Groundwater Transfer Review Summary Form

Transfer/PA # T- 14646

Application: T-14646

Applicant Name: Hillsboro Landfill, Inc.

Modeled drawdown for WASH 9658 as a result of pumping Authorized POA WASH 1130

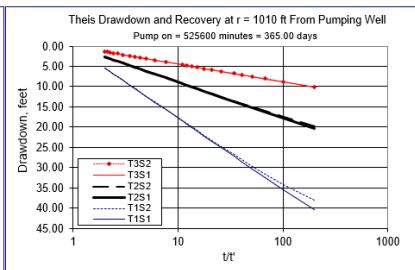
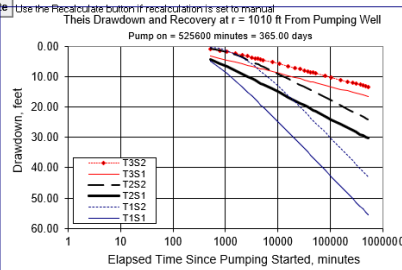
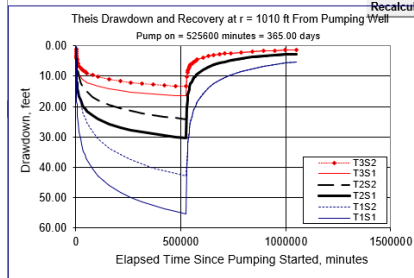
☒ Yes ☐ No Comments: Authorized POA WASH 1130 is located approximately 1,010 feet from WASH 9658, an authorized POA for Certificate 35603. The proposed APOA WASH 9628 would be located 670 feet from WASH 9658. The reduced intervening distance proposed by this change would likely result in an increase in interference with WASH 9658.

☐ Yes ☒ No If yes, explain: The potential change in interference to WASH 9658 from Proposed APOA WASH 9628 as compared to WASH 1130 was evaluated with the maximum authorized rate of 162 gpm. The results are shown on the attached figures.

The reduced intervening distance between proposed APOA WASH 9628 and WASH 9658 is estimated to potentially increase interference by 3-5 feet under likely scenarios. Therefore, the proposed change is unlikely to result in another groundwater right not receiving the water to which it is legally entitled.
